Casino Winner Technical Bulletin

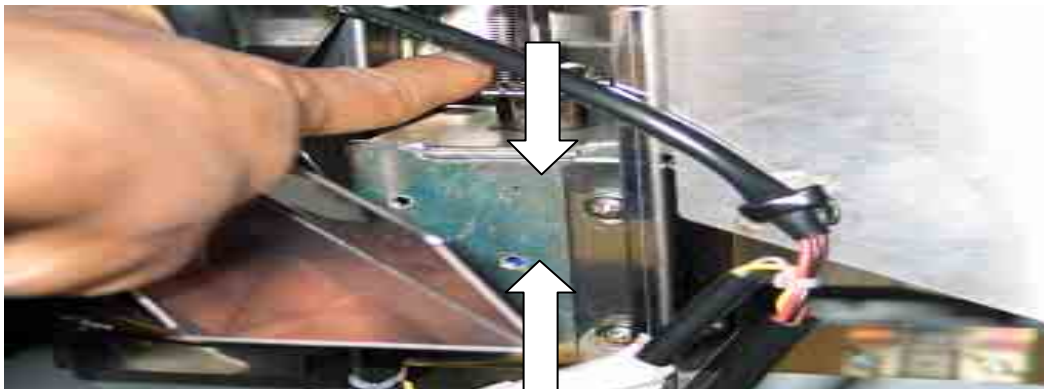
It has come to our attention that a small number of customers have experienced a problem with their new Casino Winner pusher from Brent/Namco whereby error code 5-13 is displayed, causing the machine to lock up until it is reset. We have discovered that the position of the payout solenoid is critical to its effective operation and may need to be adjusted on your machine if this error is experienced. This is a simple operation taking just a few minutes and full instructions are provided below. Please contact our Customer Service dept. on 02083246120 should you require further information.

Please adjust the payout solenoid as follows:

1. Refer to p147 of the operation manual if necessary.
2. Slacken off the two retaining bolts holding the solenoid as shown in the photograph below.

3. While holding down the plunger as shown, bring up the solenoid. When the bottom of the plunger touches the bottom of the solenoid, retighten the two retaining bolts.

6. Check the movement of Solenoid and Sensor using the test facility.
